2020 Impaired Waters List

Summary of Public Comments and the WDNR's Responses

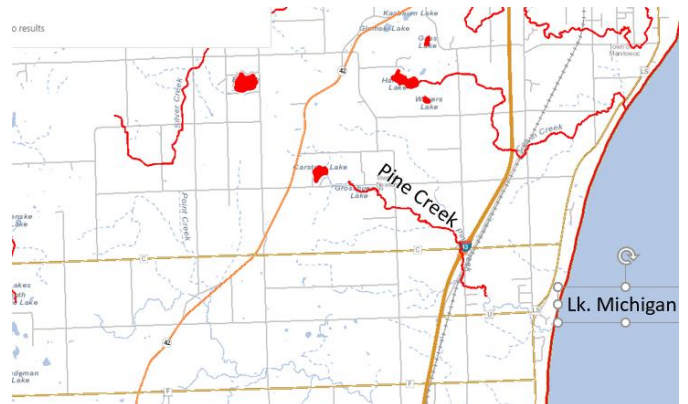
MUD CREEK AND PINE CREEK – (WBIC 75000 and 66300) “On the LAL topic, not sure if you have gotten this comment yet, but I think there is a proposed TP listing on a LAL reach. Let me know what you think.

Proposed listing: Mud Creek (Reedsville) T19n, R21e, S34

Impairment: Total Phosphorus

WBIC: 75000

Assessment Unit: 9866

Action: Proposed for List

Here is the LAL information in NR 104

41.	Mud Creek – Manito- woc River (Reedsville)	From the Reedsville STP downstream to the Man- itowoc River	Noncontinuous	II	B
-----	---	--	---------------	----	---

RESPONSE: Mud Creek and Pine Creek both have Limited Aquatic Life (LAL) determinations in Wisconsin Administrative Code NR 104. Based on phosphorus criteria outlined in Wisc. Admin. Code NR 102, LAL waters do not have applicable phosphorus criteria. For Pine Creek, after the internal review of water quality assessments it was noted that this creek is a LAL water and the phosphorus listing made in 2012 was incorrect. While phosphorus is high in Pine Creek, this water does not have an upper limit set in code and therefore cannot be listed.

Mud Creek was segmented based on the LAL determination in NR 104. The phosphorus samples were taken on the LAL portion of the stream, so neither segment is recommended for phosphorus listing during the 2020 cycle. This listing recommendation has been removed from the draft 2020 impaired waters list.
